# UNITED STATES PATENT AND TRADEMARK OFFICE

APPLICATION NO.	FILING DATE	FIRST NAMED INVENTOR	ATTORNEY DOCKET NO.	CONFIRMATION NO.
10/065,495	10/24/2002	Ronald Scott Bunker	839-1333	9074

<b>Office Action Summary</b>	<b>Application No.</b> 10/065,495	<b>Applicant(s)</b> BUNKER, RONALD SCOTT	
	<b>Examiner</b> William H. Rodriguez	<b>Art Unit</b> 3746

### DETAILED ACTION

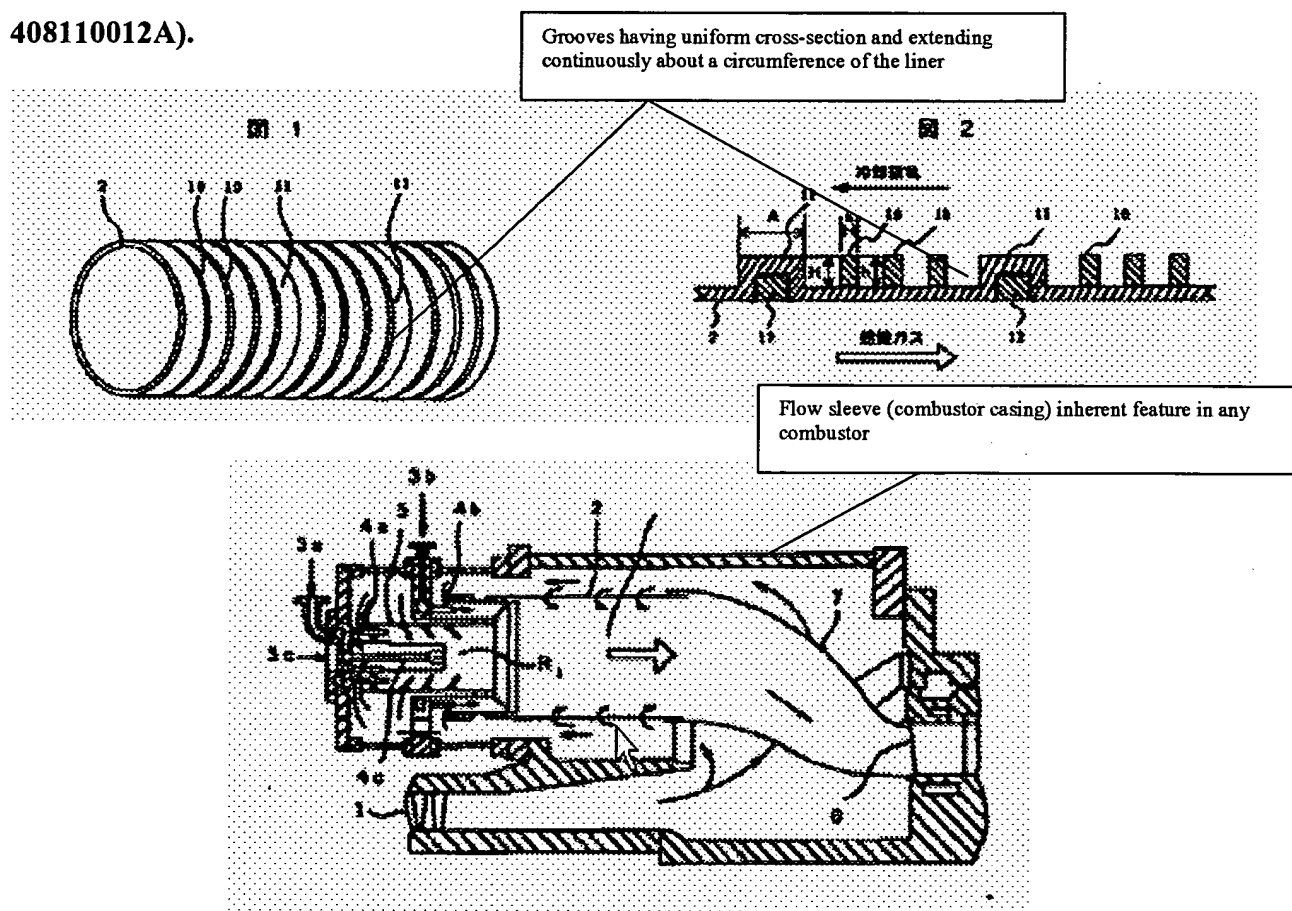
3. Claim 17 is rejected under 35 U.S.C. 102(b) as being anticipated by **Innami et al. (JP 408110012A)**.

**Innami** teaches a combustor for a gas turbine, the combustor including a liner having a substantially cylindrical shape; a flow sleeve surrounding said liner; a first plurality of axially spaced, continuous circumferential grooves formed in an outside surface of said liner, each groove having a uniform cross-section and extending continuously about a circumference of the liner. See particularly **Figures 1, 2 and 8**.

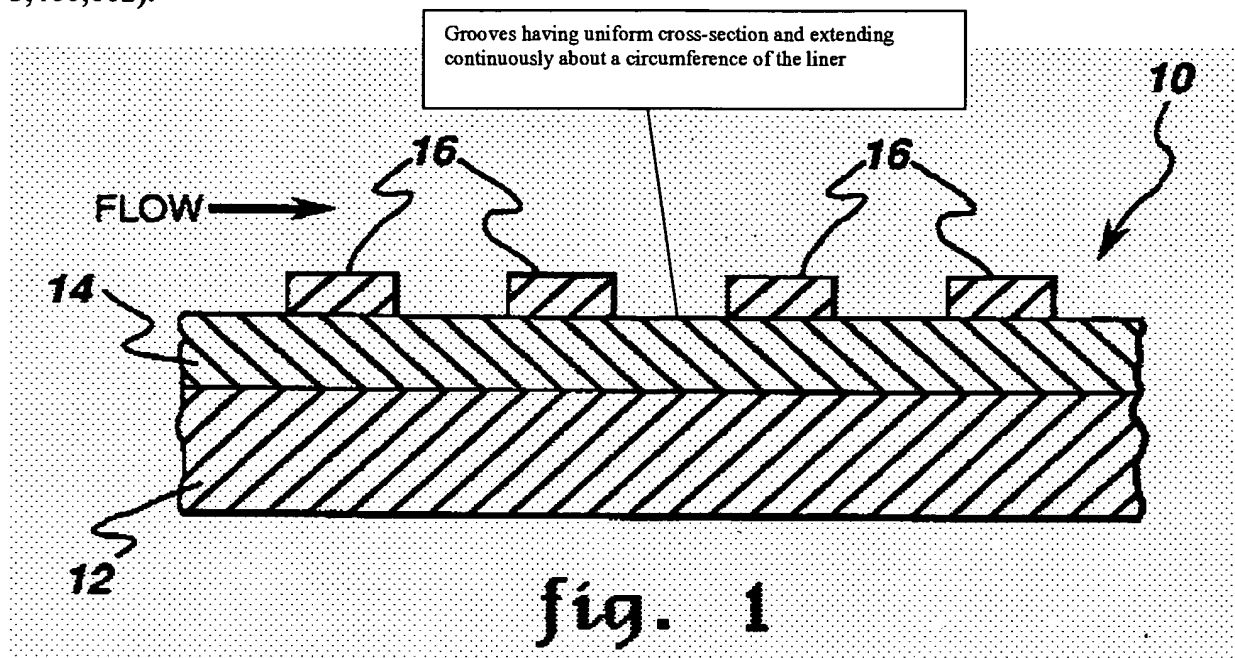
4. Claim 17 is rejected under 35 U.S.C. 102(b) as being anticipated by Correa (US 5,460,002).

Correa teaches a combustor for a gas turbine, the combustor including a liner having a substantially cylindrical shape; a flow sleeve surrounding said liner (not shown but inherent, i.e., casing of combustor surrounding combustor liner); a first plurality of axially spaced, continuous circumferential grooves formed in an outside surface of said liner, each groove having a uniform cross-section and extending continuously about a circumference of the liner. See particularly Figure 1.

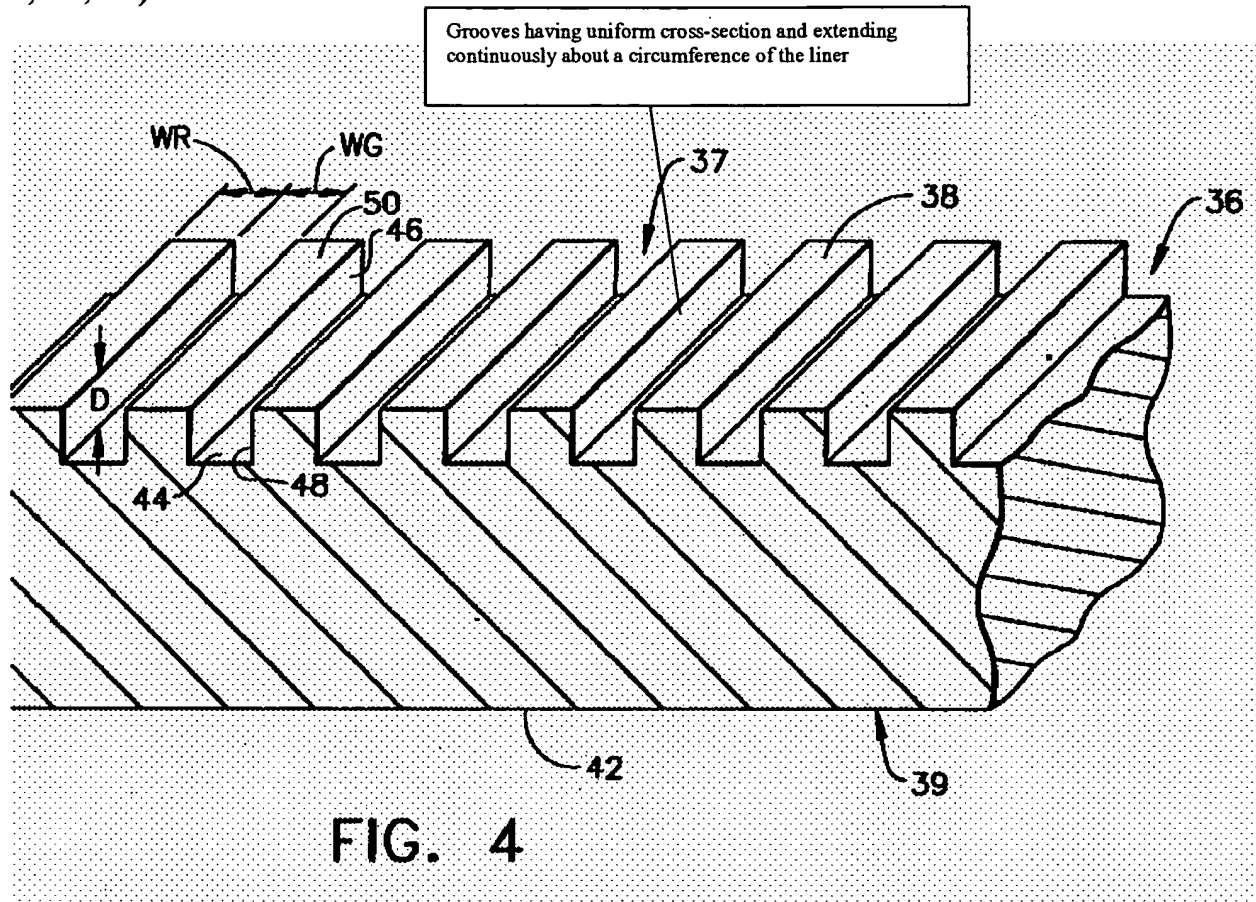
5. Claim 17 is rejected under 35 U.S.C. 102(b) as being anticipated by Ward (US 5,327,727).

Correa teaches a combustor for a gas turbine, the combustor including a liner having a substantially cylindrical shape; a flow sleeve surrounding said liner (not shown but inherent, i.e., casing of combustor surrounding combustor liner); a first plurality of axially spaced, continuous circumferential grooves formed in an outside surface of said liner, each groove having a uniform cross-section and extending continuously about a circumference of the liner. See particularly Figure 1.

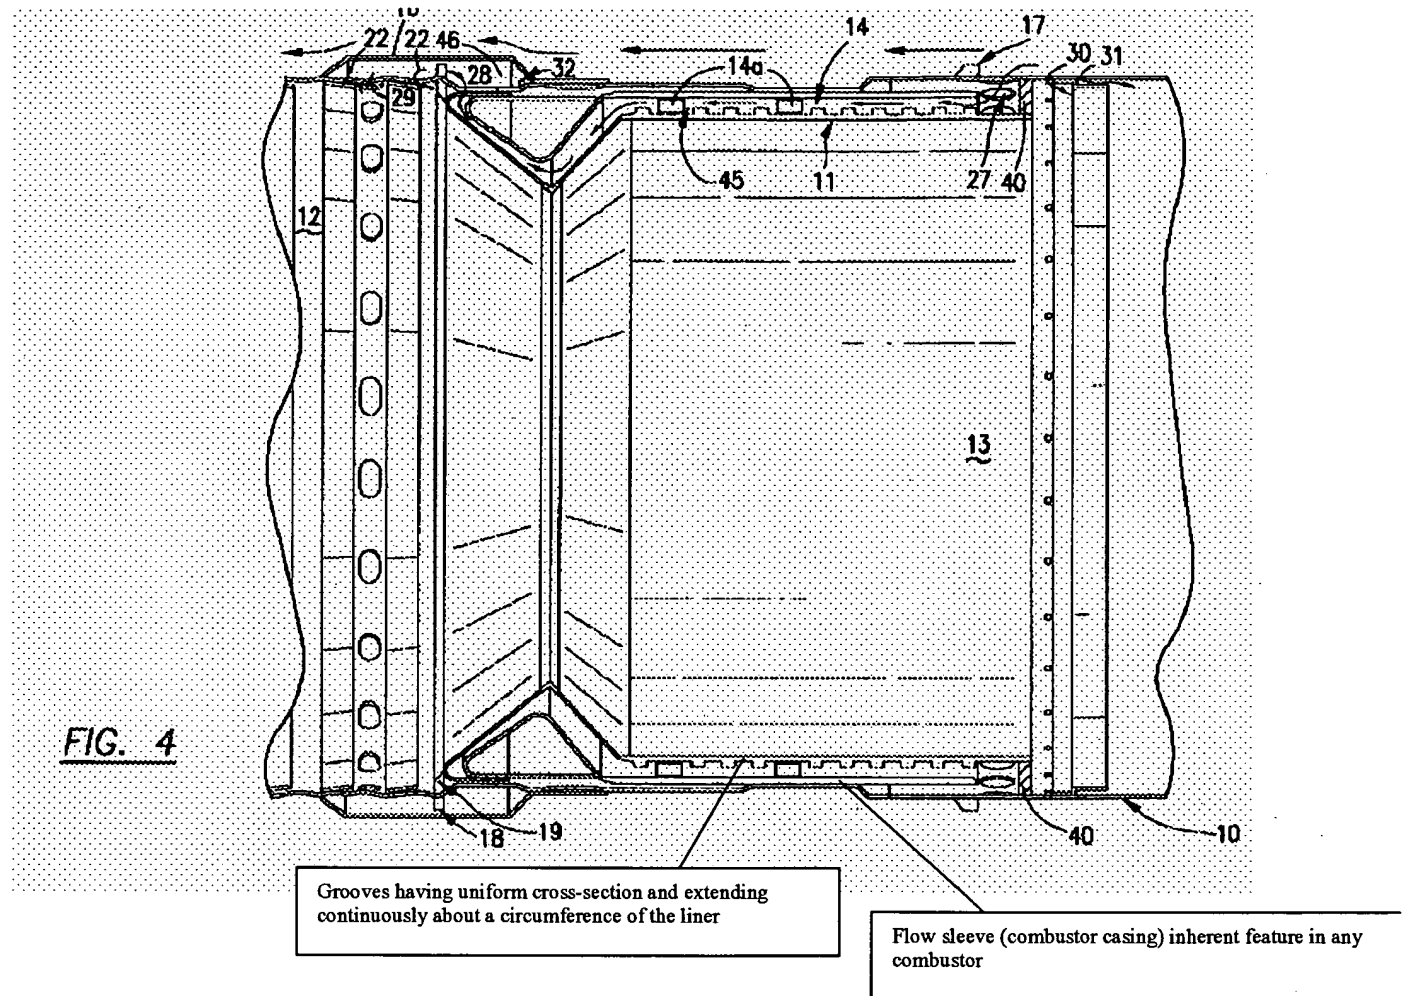
6. Claim 17 is rejected under 35 U.S.C. 102(e) as being anticipated by Kraft et al. (US 6,484,509).

**Kraft** teaches a combustor for a gas turbine, the combustor including a liner having a substantially cylindrical shape; a flow sleeve surrounding said liner; a first plurality of axially spaced, continuous circumferential grooves formed in an outside surface of said liner, each groove having a uniform cross-section and extending continuously about a circumference of the liner. See particularly **Figures 4 and 6**.

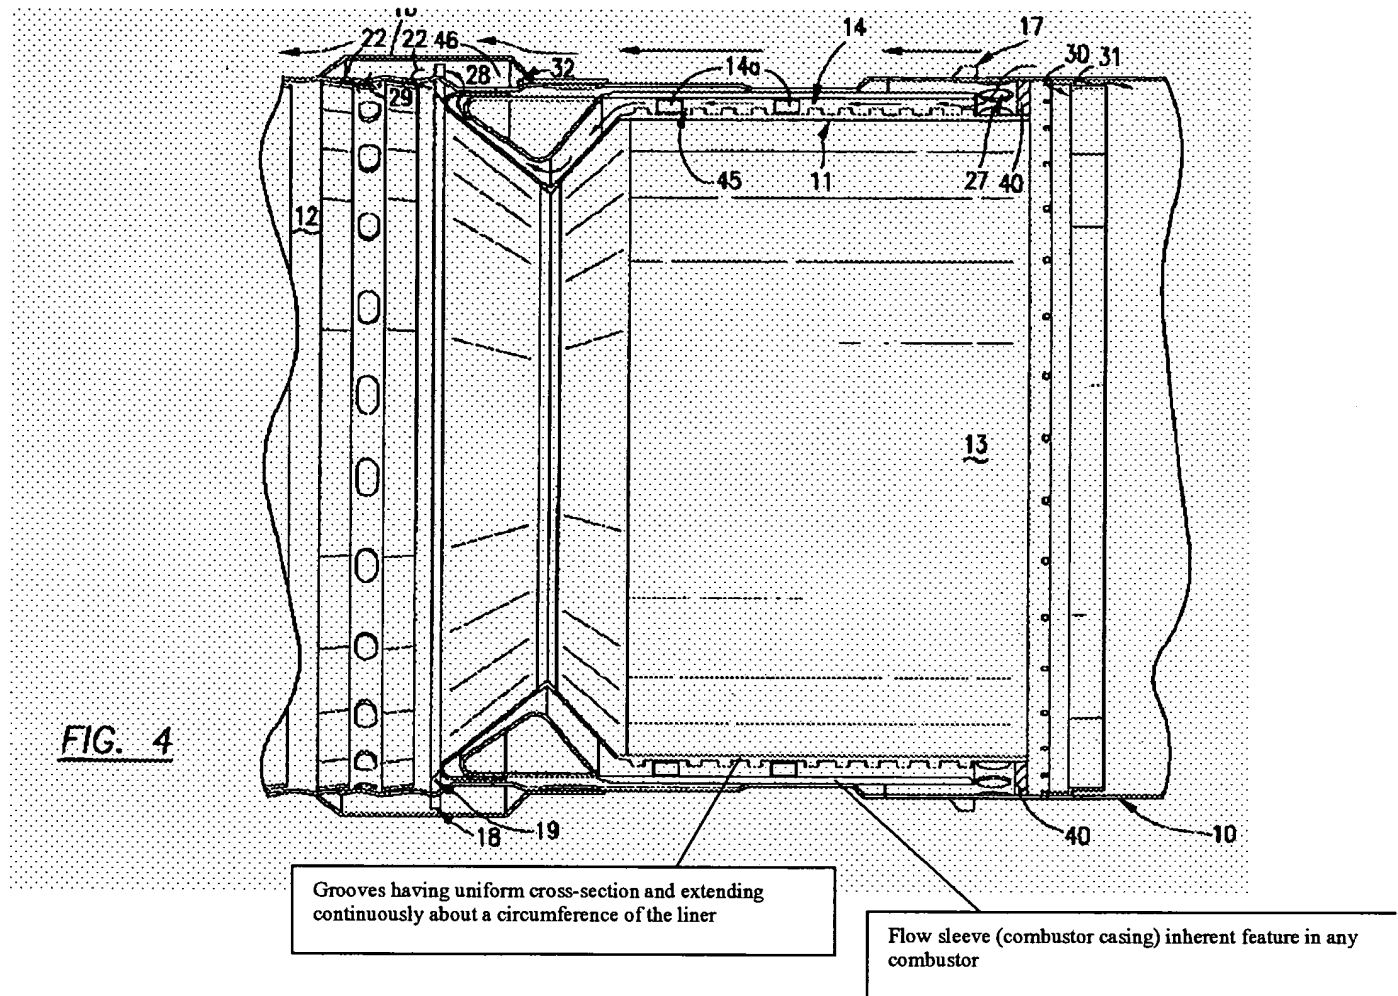
7. Claim 17 is rejected under 35 U.S.C. 102(e) as being anticipated by Kraft et al. (US 6,446,438).

**Kraft** teaches a combustor for a gas turbine, the combustor including a liner having a substantially cylindrical shape; a flow sleeve surrounding said liner; a first plurality of axially spaced, continuous circumferential grooves formed in an outside surface of said liner, each groove having a uniform cross-section and extending continuously about a circumference of the liner. See particularly **Figures 4 and 6**.
